ITEM 3

Application Reference	DC/083249
Location:	Vauxhall Industrial Estate Greg Street South Reddish Stockport SK5 7BR
PROPOSAL:	Demolition of existing buildings and structures on Site, and proposed industrial estate redevelopment to provide approximately 19,120sq.m (205,767 sq.ft) of employment floor space (Use Classes B2, B8 and E(g)) over 28 no. employment units together with associated parking and infrastructure.
Type Of Application:	Full Application
Registration Date:	17.11.2021
Expiry Date:	Extension of Time agreed to 11 th July 2022
Case Officer:	Jeni Regan
Applicant:	Vauxhall Industrial Estate (Stockport) Limited
Agent:	SATPLAN Ltd

Site Layout

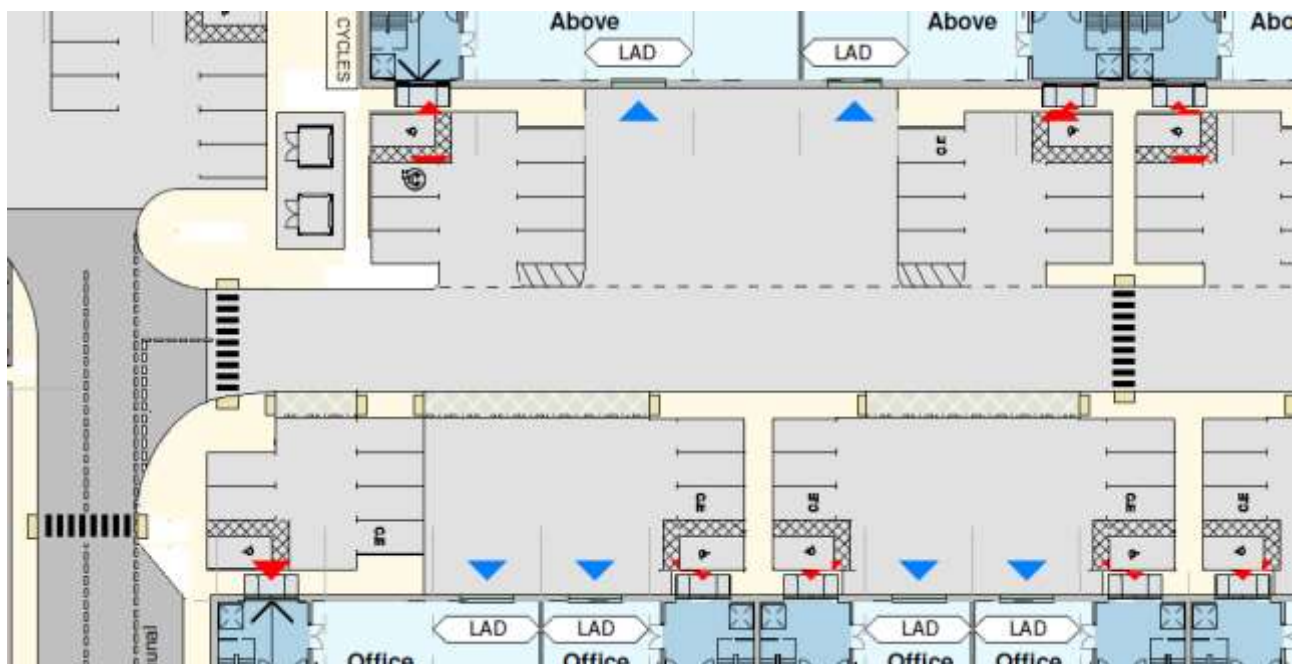
It is therefore considered there is a need for the site layout to be amended so as to address the issues outlined. This should be possible without significant amendments to the site layout. The drawing below provides an indication of what would be acceptable. This could be replicated across the site.

I therefore recommend that the application is also deferred to allow the applicant to revise the site layout with the aim of addressing these issues.

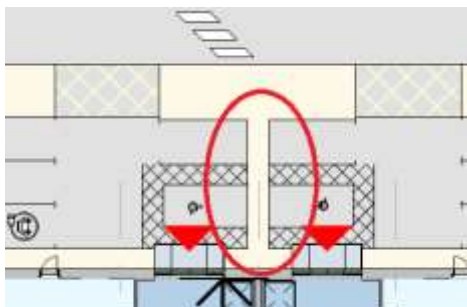
In my comments of the 9th February I outlined that whilst I had no objection, in principle, to the continued use of the site for employment use, noting that the proposal will double the amount of floor area at the site which will result in a significant increase in staff and visitors travelling to the site and an increase in vehicle movements on local streets, I concluded that there is a need for some of existing deficiencies to be addressed and pedestrian, cycle and bus infrastructure improved to encourage and allow staff and visitors to the development to travel to the site by sustainable modes. I therefore recommended that the application was deferred to allow the applicant to review this issue in conjunction with the Highway Authority and develop a comprehensive scheme of measures to improve access to the development. The applicant, however, has not approached the Council to discuss this matter, nor has provided any information or comment on this issue. As such, this issue remains outstanding and still needs to be addressed.

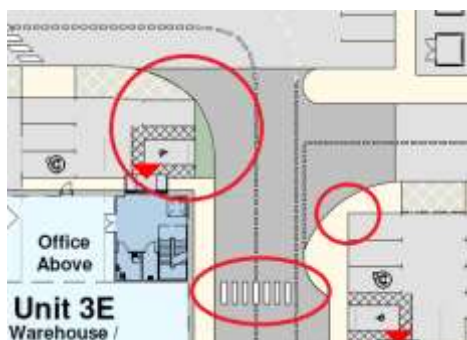
- 1) A number of footpaths within the site (e.g. between parking spaces) are very narrow which could affect pedestrian access within the site, notably by those with disabilities (footpaths should be a minimum of 1.5m wide, 2m, where possible).

- 2) There is no pedestrian route past Unit 3E and the footpath in front of Unit 5A has a pinch point (see plan below).

- 3) The pedestrian crossing on the main site access conflicts with the loading bay (see plan above)
- 4) The tie in between the access and the layby on the site access road is sub-standard (see plan below). The kerb line at the access should tie in with the outer extent of the layby / the dashed in and then splay in (or similar).
